Re: Docket No. 020408-SU; Application of Alafaya Utilities, Inc., for Rate Increase in
Seminole County, Florida
Our File No.: 30057.46

Re: Docket No. 020408-SU
Application for Rate Increase in Seminole County by Alafaya Utilities, Inc.
STAFF'S FIRST DATA REQUEST

ALAFAYA UTILITIES, INC.

Utility's Response to FDEP Inspection Reports and Notices

ALAFAYA WWTP SITE PLAN AND FLOW DIAGRAM

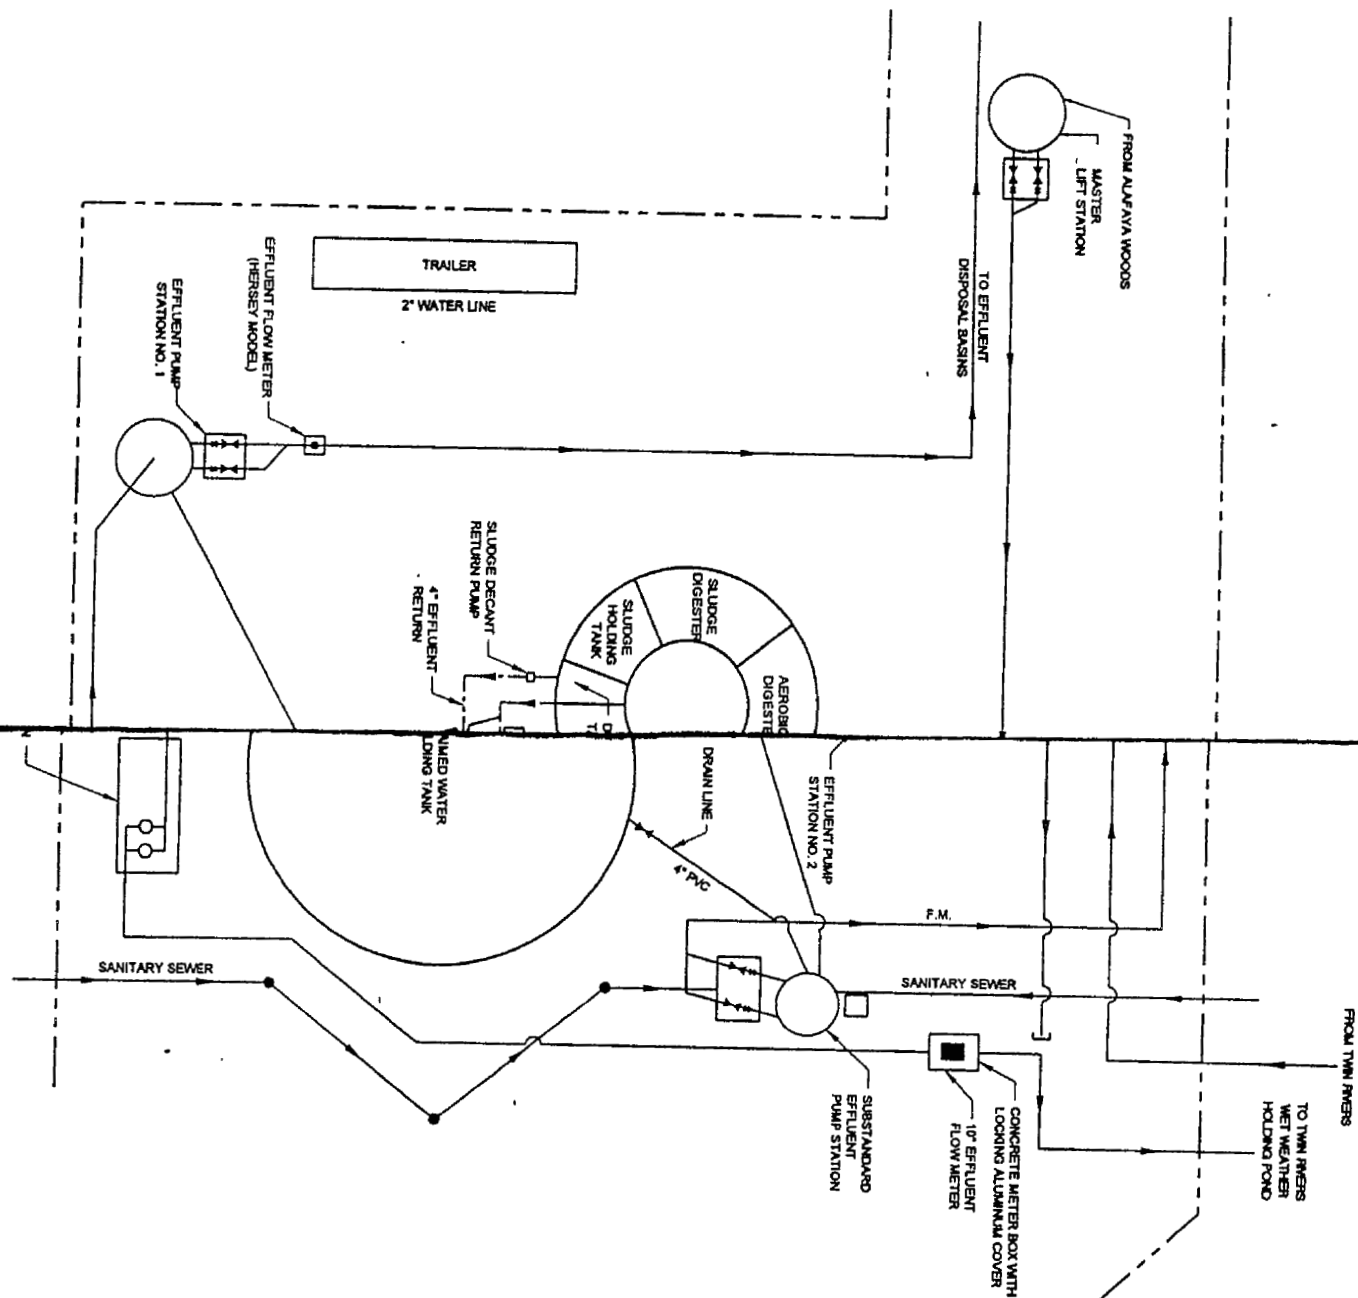
FDEP Comment: Please provide information related to the accuracy of the flow data reported in the discharge monitoring reports (DMR's). Also, indicate whether flows were measured by a flow meter or other method, the location of the flow meter, the last date of calibration, and the person who performed the calibration.

Response: Figure 1 shows the location of the flow-meters at the plant. The latest calibration data for the meters is attached as requested. The reported flow is based on the Facility effluent meters, one to the percolation ponds and one to the public access reclaimed system.
